PIC18F6390/6490/8390/8490

PIC18F6390/6490/8390/8490 Data Sheet Errata

Clarifications/Corrections to the Data Sheet:

FIGURE 5-5: DATA MEMORY MAP FOR PIC18F6390/6490/8390/8490 DEVICES

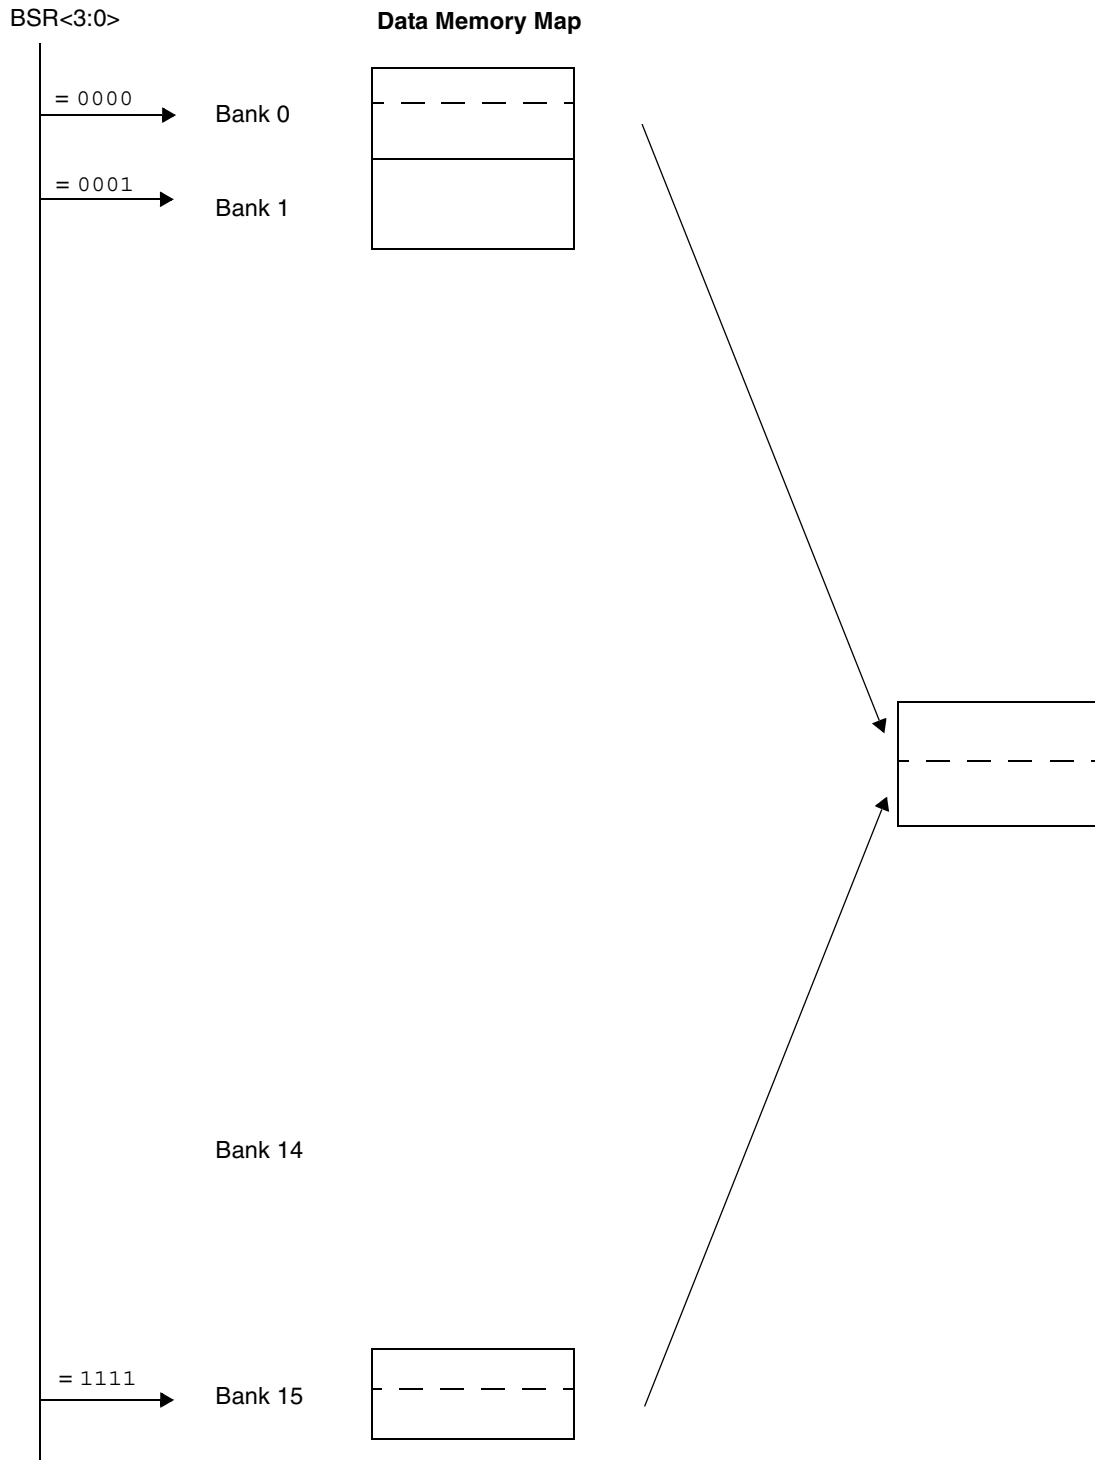
In Figure 5-5 of the Device Data Sheet, the address range, F00h to F58h, has been corrected to “**Unimplemented**” rather than “GPR”.
